# UNITED STATES PATENT AND TRADEMARK OFFICE

APPLICATION NO.	FILING DATE	FIRST NAMED INVENTOR	ATTORNEY DOCKET NO.	CONFIRMATION NO.
10/724,307	11/28/2003	Chi Lam Wong		1426
30265	7590	10/19/2005	EXAMINER	
RAYMOND Y. CHAN 108 N. YNEZ AVE., SUITE 128 MONTEREY PARK, CA 91754			PRICE, CARL D	
			ART UNIT	PAPER NUMBER
			3749	
DATE MAILED: 10/19/2005

<b>Office Action Summary</b>	<b>Application No.</b> 10/724,307	<b>Applicant(s)</b> WONG, CHI LAM	
	<b>Examiner</b> CARL D. PRICE	<b>Art Unit</b> 3749

FIG. 3

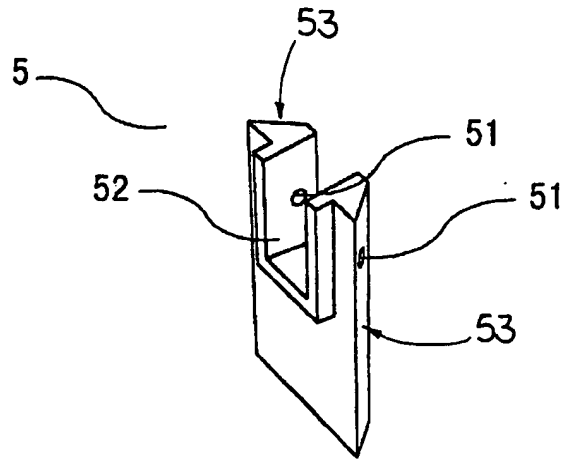
The drawings are objected to because the drawing Figure 3 presented under the Heading “DRAWING AMENDMENTS” in “Attachment 1” of the response filed on 03/21/2005 is not marked “**Replacement Sheet**” or “**New Sheet**” pursuant to 37 CFR 1.121(d). Corrected drawing sheets in compliance with 37 CFR 1.121(d) are required in reply to the Office action to avoid abandonment of the application.
